Raspberry Biscotti Changes

Lot 39

Change Requests

Fig. 4
Sunroom entrance with transoms above

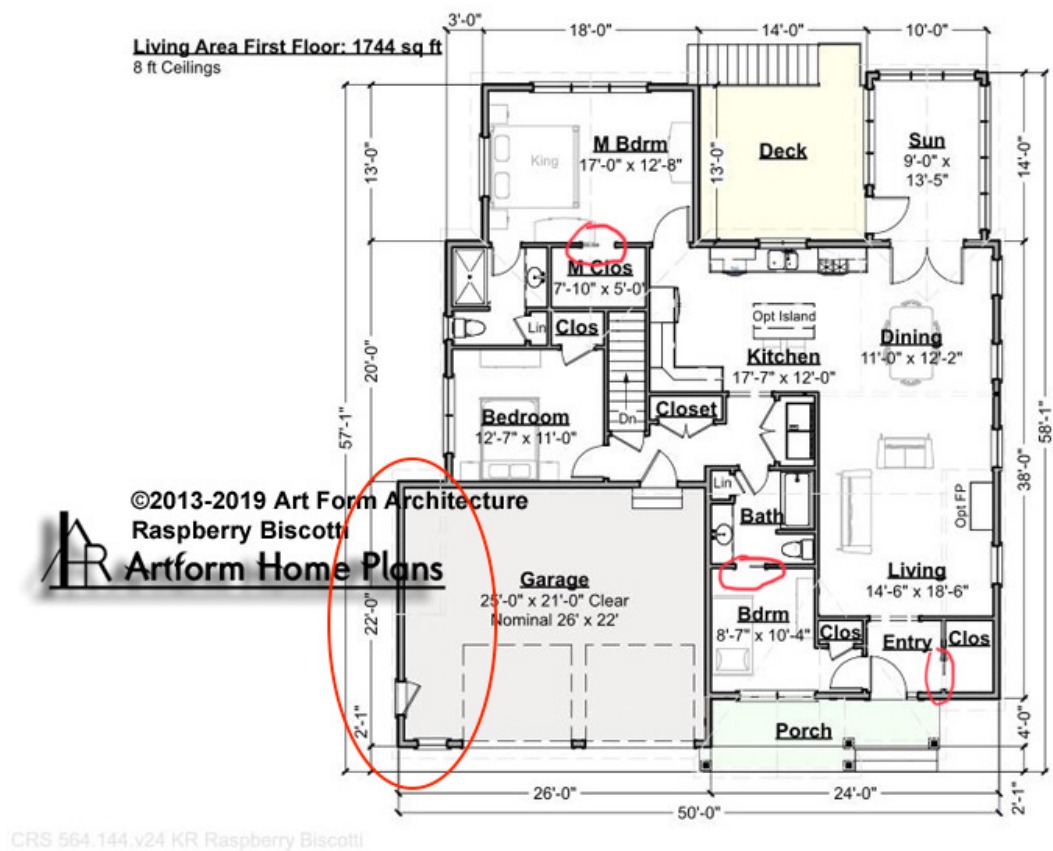
- 9ft Ceilings
- Fireplace
- A/C
- Hardwood in all rooms
- Substitute red oak with hardwood material TBD
- Wider kitchen window (see Fig. 1)
- Sunroom entrance (see Fig. 4)
- Transoms above double hung windows (see Fig. 2-4)
- Pocket Doors in front bedroom/bathroom, master closet, and entry closet as per 564.144.v24 KR (see Fig. 5)
- Wider garage with window as per 564.144.v24 KR (see Fig. 5)
- Composite decking (e.g., TREX) instead of pressure treated
